[Docket No. 2003-NE-52-AD Amendment 39-13410; AD 2003-24-12R1]

Airworthiness Directives; Pratt & Whitney JT9D-3A, -7, -7A, -7F, -7H, -7AH, and -7J Turbofan Engines

2003-24-12R1 Pratt & Whitney: Amendment 39-13410. Docket No. 2003-NE-52-AD. Revises AD 2003-24-12, Amendment 39-13381.

Figure 1

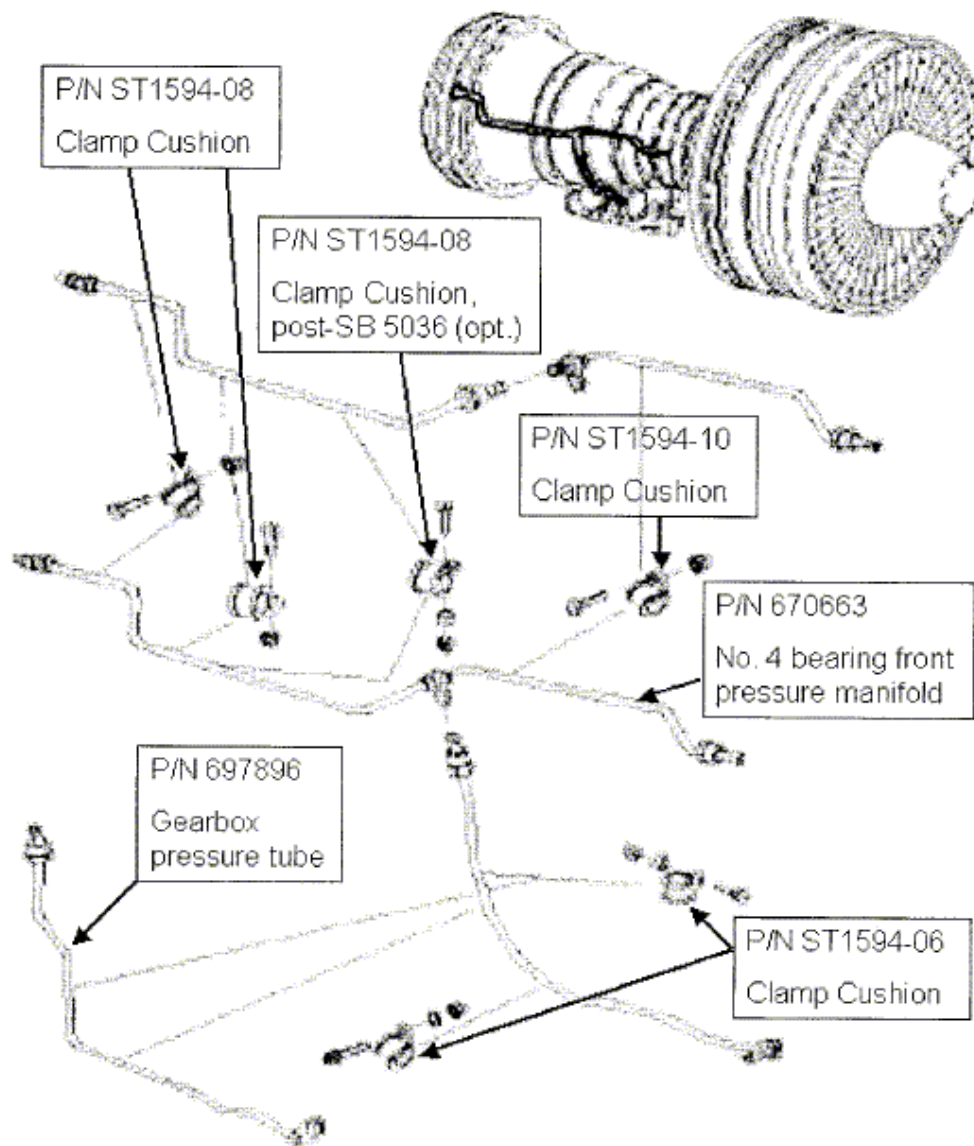
Since that AD was issued, errors in the depicted clamping configuration have been found. The clamping configuration must be correct to ensure that AD compliance can be achieved. Also, an operator has requested that as an option to inspecting dented tubing by passing a ball bearing through the tube, to add dent depth limit criteria for each specific part number tube. The manufacturer supports this optional method and we have added it to the AD. This method avoids having to disconnect the tube from the engine.

(d) This AD results from the need to correct errors in depicted clamping, to ensure that AD compliance can be achieved. The actions specified in this AD are intended to prevent engine fires caused by failed gearbox pressure tubes or failed No. 4 bearing front pressure manifolds.

(f) Visually inspect the clamp assemblies, P/Ns ST1594-06, ST1594-08, and ST1594-10, (see Figure 1 of this AD) that attach the gearbox pressure tube and the No. 4 bearing front pressure manifold to the engine. Replace clamp assemblies before further flight that are rejected by any of the following rejection criteria:

(g) If one or more clamp assemblies are rejected as described in paragraph (f) of this AD, or out of position or missing (see Figure 1 of this AD), clean any debris and oil from the outer surface of the gearbox pressure tube and No. 4 bearing front pressure manifold and visually inspect the tube and manifold. Repair or replace the affected tube or manifold before further flight if it is rejected by any of the following rejection criteria:

- (1) Cracks, wear, or distortion in clamp metal.
- (2) Clamp cushions that are worn, compacted, cracked, coming apart in chunks, deteriorated, or missing. A reddish powder found around the clamp is an indication of deterioration.

- (1) Nicks, chafing, scratches, and or pitting 0.003 inch or greater in depth.
- (2) Dents within 0.25 inch of the ferrules or will not permit free passage of a ball having a minimum diameter of 80% of the tubing inner diameter.
- (3) Corrosion that is unable to be removed by a light polishing.
- (4) Tube or manifold is leaking oil.
- (5) As an option to the dent inspection method specified in paragraph (g)(2) of this AD, measure tube dent depth and use the following rejection criteria:

- (i) Dents in the gearbox pressure tube, P/N 697896, greater than 0.055-inch depth.
- (ii) Dents in the No. 4 bearing front pressure manifold, P/N 670663, forward of the tee fitting, greater than 0.100-inch depth.
- (iii) Dents in the No. 4 bearing front pressure manifold, PN 670663, aft of the tee fitting, greater than 0.080-inch depth.

- (h) Ensure that the gearbox pressure tube, No. 4 bearing front pressure manifold, and clamp assemblies are properly positioned, before further flight, as shown in Figure 1 of this AD.
- (i) Information on general inspection of these parts can be found in the Boeing 747 Aircraft Maintenance Manual, section 72-00-00, and in PW Standard Practices Manual, P/N 585005.
